Sydney Central City Planning Panel
Section 4.55(2) Assessment Report
Environmental Planning & Assessment Act 1979

Summary	
Panel reference no.	PPSSCC-804
DA No:	DA/61/2018/C
Local Government Area (LGA):	City of Parramatta
Property:	48, 49, 53, and 54 Beecroft Road, Epping 52, 54, and 54R Rawson Street, Epping
Proposal:	Section 4.55(2) modification to approved 21 storey mixed use development, including revisions to podium design and layout, tower façade, unit mix, basement and car parking.
Date of receipt:	26 February 2026
Applicant:	DGS Epping Development Pty Ltd
Owner:	Linsland Pty Ltd & Epping Tower Pty Ltd
Property owned by a Council employee or Councillor:	No
Political donations/gifts disclosed:	None
Submissions received:	Five (5)
Unique objections received:	Five (5)
Recommendation:	Approval
Regional development criteria:	Original development application classified as regionally significant (>\$30 million EDC). Subject modification application meets criteria under <i>Instruction on Functions Exercisable by Council on Behalf of Sydney District or Regional Planning Panels—Applications to Modify Development Consents</i> as it represents a departure from development standards by m

Figure 5: Modifications to Lower Ground Level

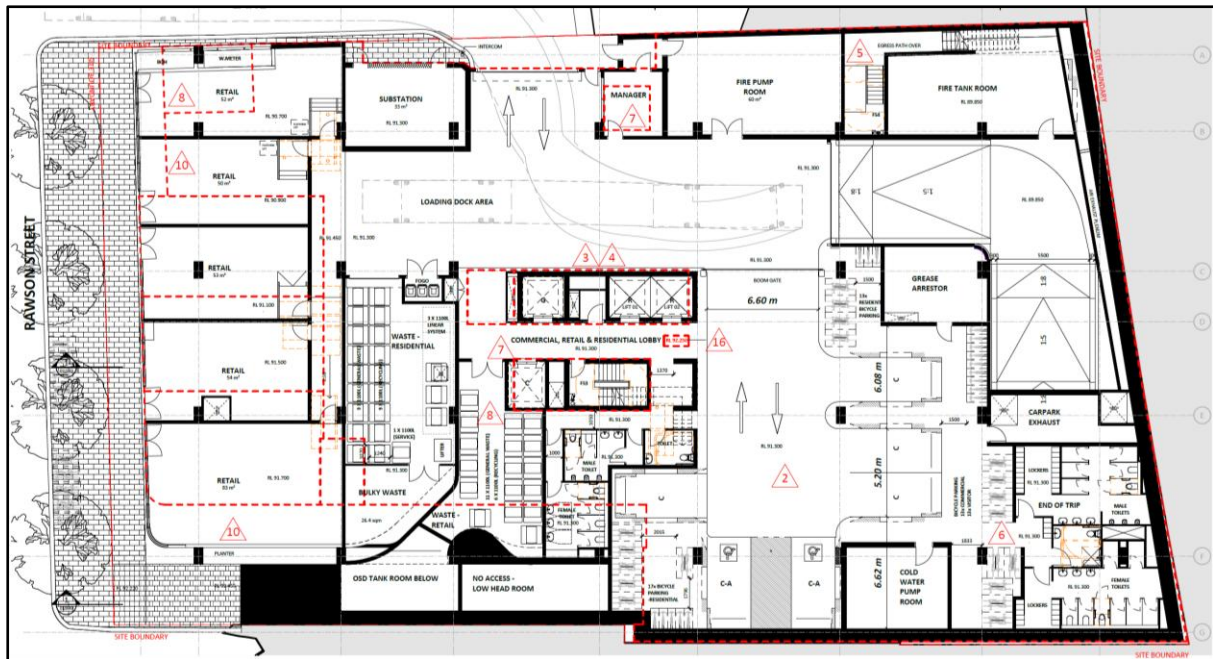
The lower ground floor layout is amended to reflect the revised core and servicing arrangements. Two additional retail tenancies are introduced along the Rawson Street frontage, and services and waste rooms are relocated. The residential lobby is removed from this level.

Figure 6: Modifications to Ground Level

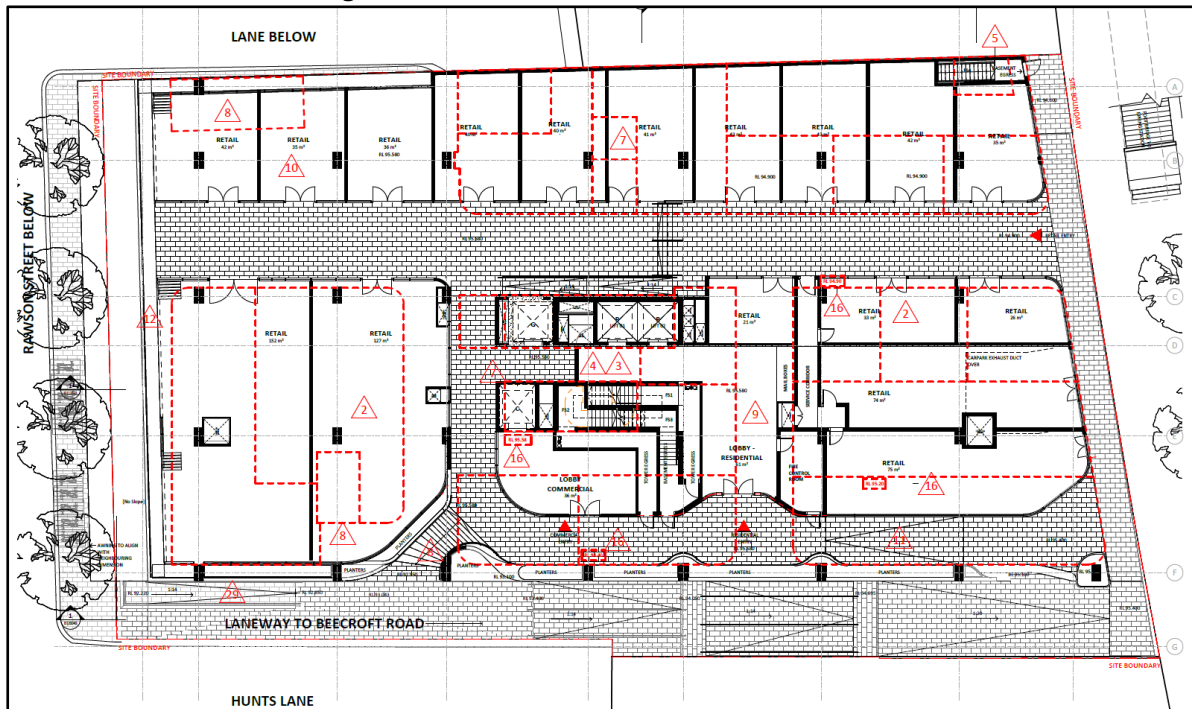
The ground floor is reconfigured to accommodate the relocated residential lobby and revised internal circulation. Retail tenancies are rearranged and expanded, and a relocated and enlarged commercial lobby is introduced with access from Beecroft Road and the pedestrian laneway. A colonnade is proposed along the southern upper ground floor elevation.

Figure 7 Basement Level 1

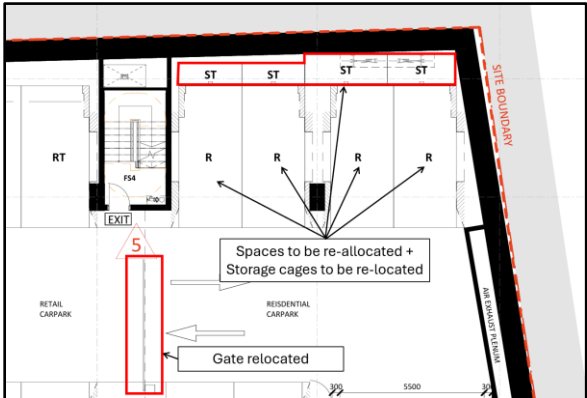
Amendments to Condition 11 are recommended, requiring the provision of a security shutter (in lieu of a boom gate as currently shown on submitted architectural plans, in accordance with requirements of Condition 99) from Basement Level 1 to Basement Level 2 to allow the re-allocation of seven (7) resident parking spaces to retail spaces. The condition also requires the relocation of storage cages into the resident-only areas of the basement car park (see figures below).
